# **LEDGE ROAD 4-LOT SUBDIVISION PLAN**

SB# 01-24

## **STAFF REPORT**

RE: Town of Hudson Planning Board Review  
Ledge Road Subdivision Plan  
Tax Map 166, Lot 11, Acct. #1350-111  
Fuss & O'Neill Reference No. 20030249.2390

SHEET TITLE:  
**SUBDIVISION PLAN**

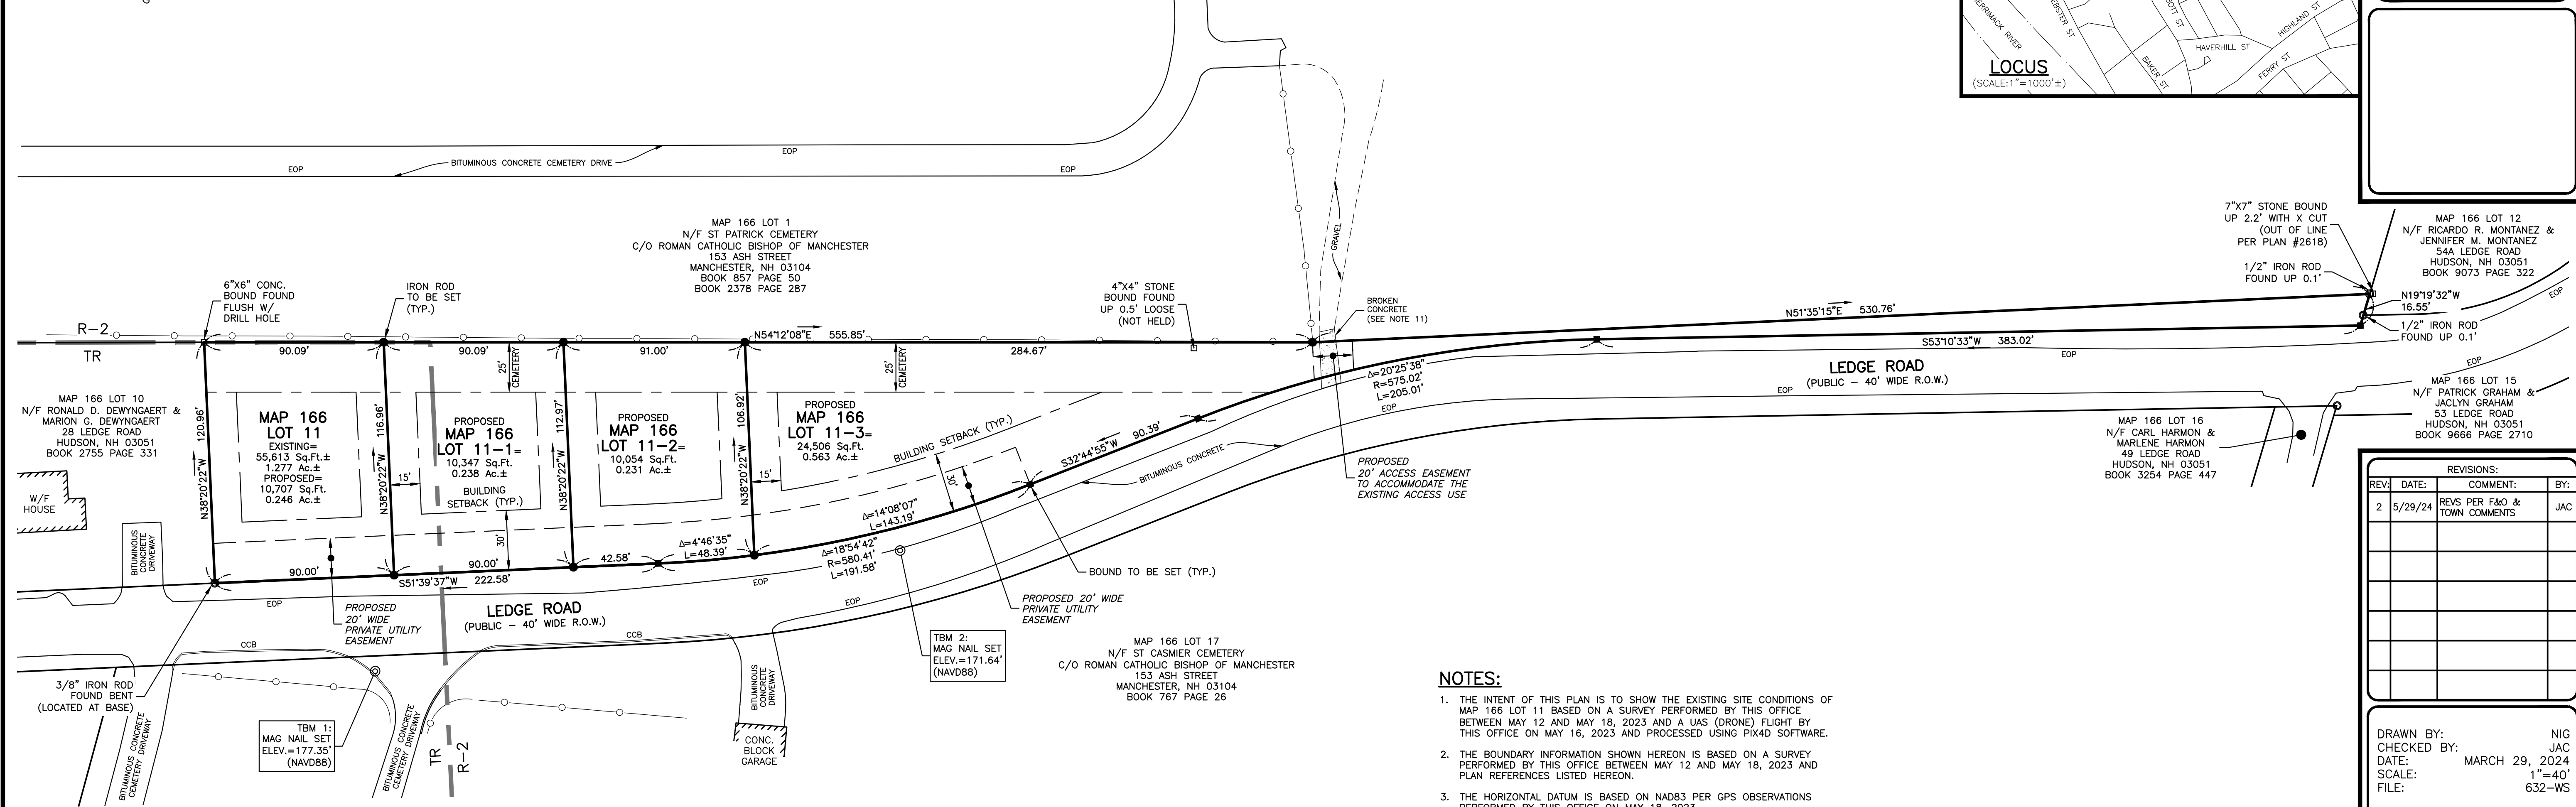
Planning Staff has identified small administrative changes recommended for the plan. On Sheet three titled “Subdivision Plan,” note #1 should state that the intent of the plan is to subdivide Map 166 Lot 11 into four single-family residential lots. Staff also recommend including in note #7 of the plan set mention of the 25’ cemetery setback, which has been marked on the plan set. No outstanding issues remain for the site now that drainage has been remediated in revision 3 of the plan set.

SHEET TITLE:  
**UTILITY PLAN W/  
 PROTOTYPICAL  
 LOT GRADING**

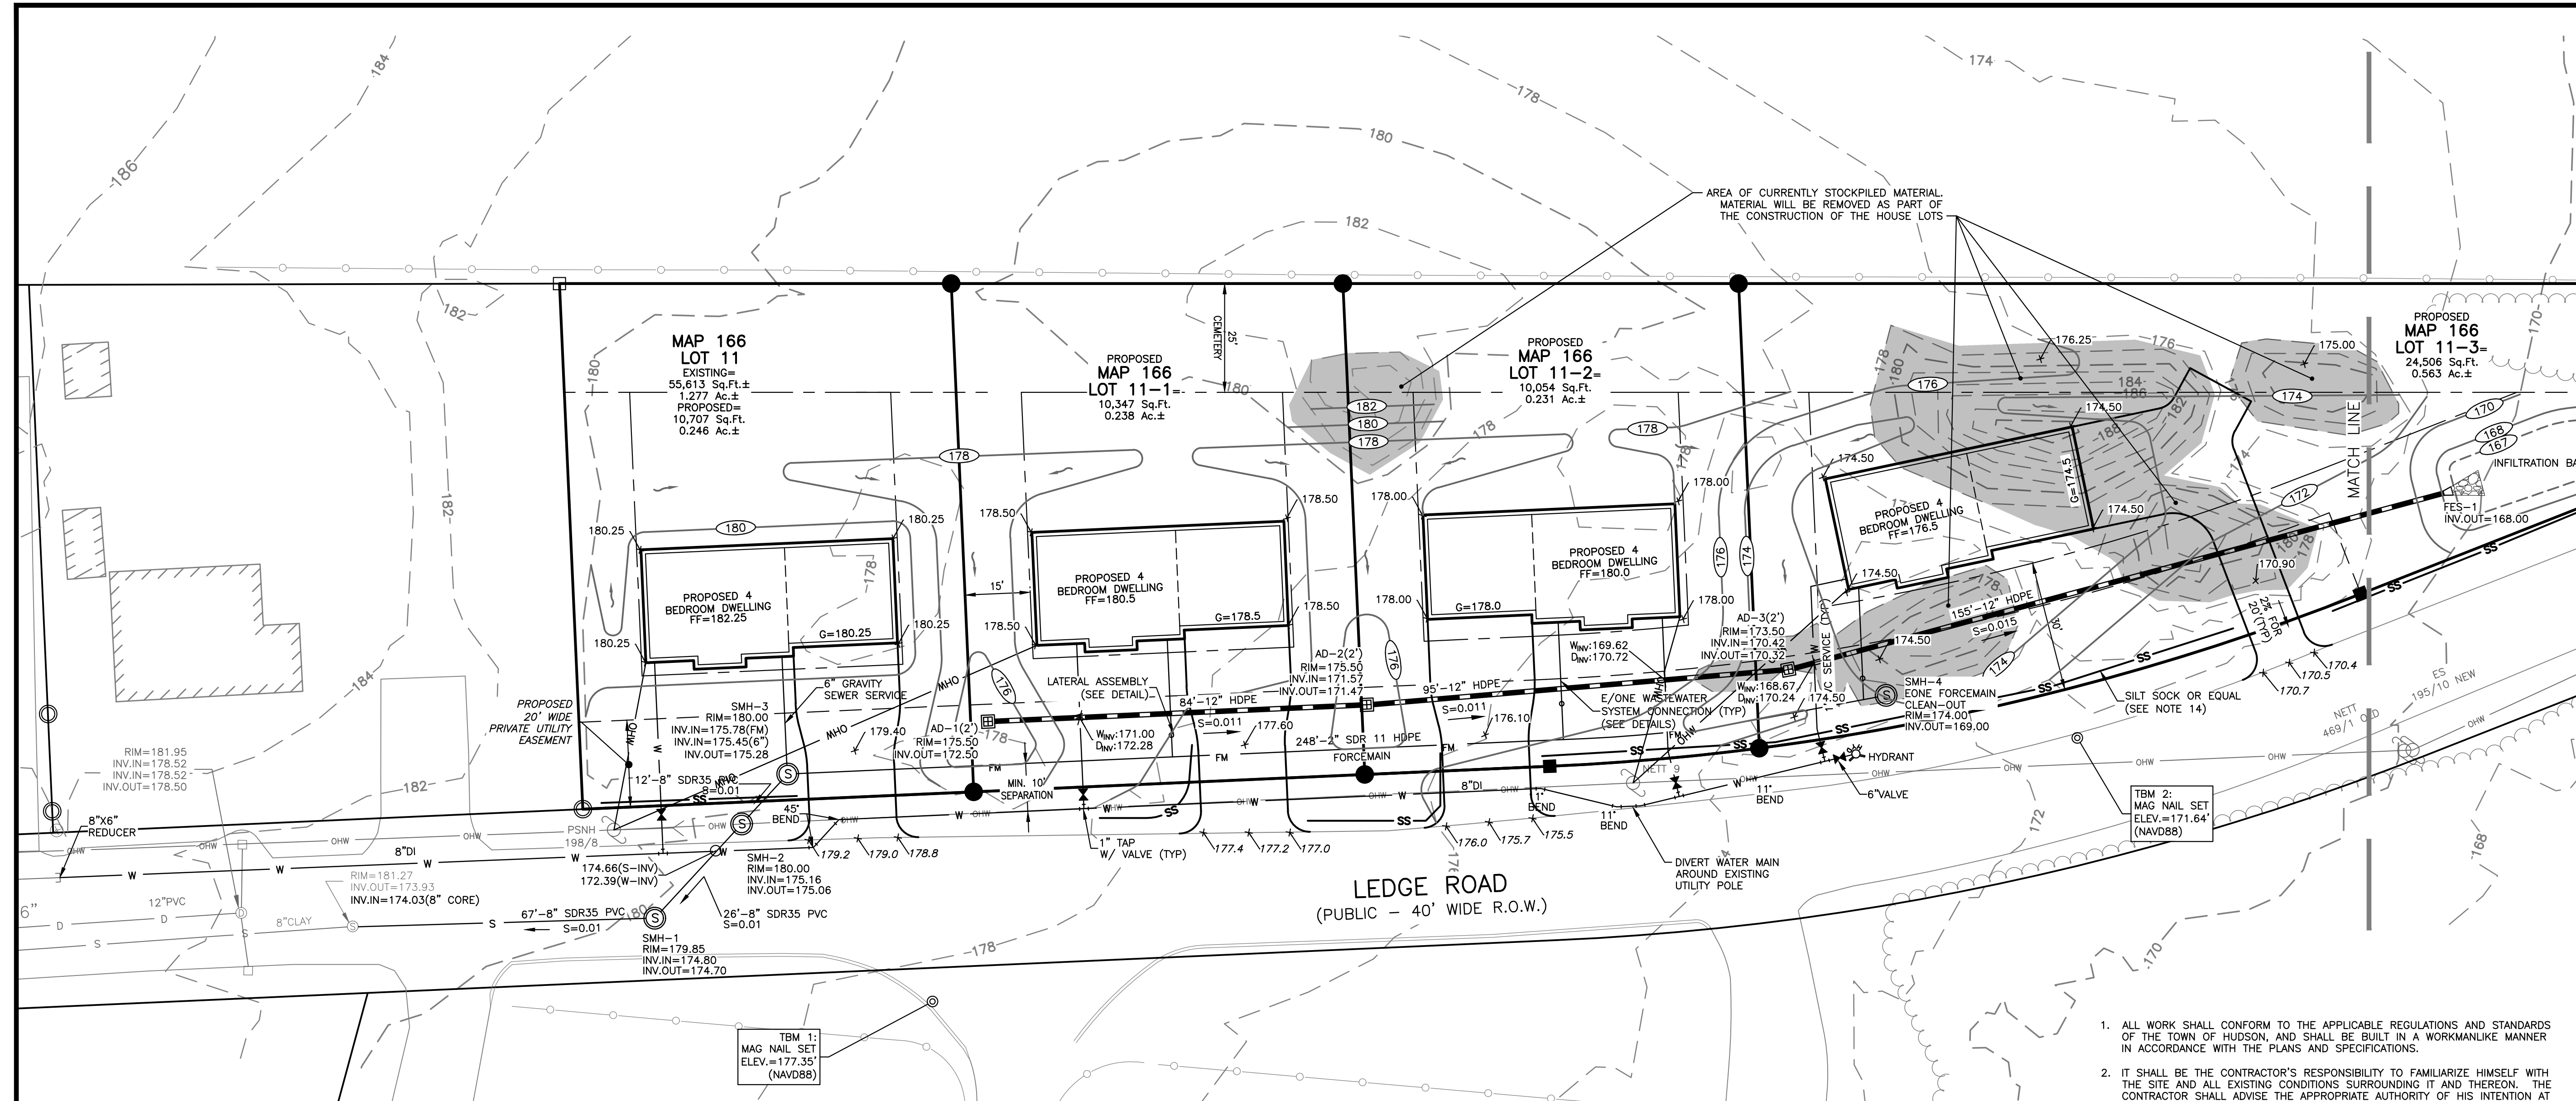
*“This looks good and you just need to add a detail about the water crossing under the drainage pipe, they will both be at 4-5’ depth range You might want to have the water line go under the drainage with some insulation in between, have the detail in before you record the plans.”*

This looks good and you just need to add a detail about the water crossing under the drainage pipe, they will both be at 4-5' depth range

- h. The applicant should add a sewer and water crossing detail to the plan set.
- i. The applicant has proposed the water main extension to be installed directly underneath overhead utility wires, and with several bends to accommodate pole locations. We recommend moving the proposed water away from the overhead wires to avoid conflicts during construction and also to eliminate some of the proposed bends.

- j. ETGTD Section 830.1. The applicant has proposed various sized water services to the lots within the subdivision. Lot 11-1 has a 6" valve off of the main, Lot 11-2's water service is not labelled, and Lot 11-3 has a 1" PVC service shown. The applicant should clarify the intent for the water service sizes and proposed materials for each Lot and confirm with the Hudson water utility that the proposed size is acceptable.

**TDG Response:** *Detail has been added to Sheet 7.*

**TDG Response:** *The water line has been centered between the edge of pavement and the ROW and has been reviewed by the Town of Hudson and as far as we are aware, do not take objection to the location.*

**TDG Response:** *The water line labeling has been updated.*

**TDG Response:** *A note has been added to Sheet 4.*
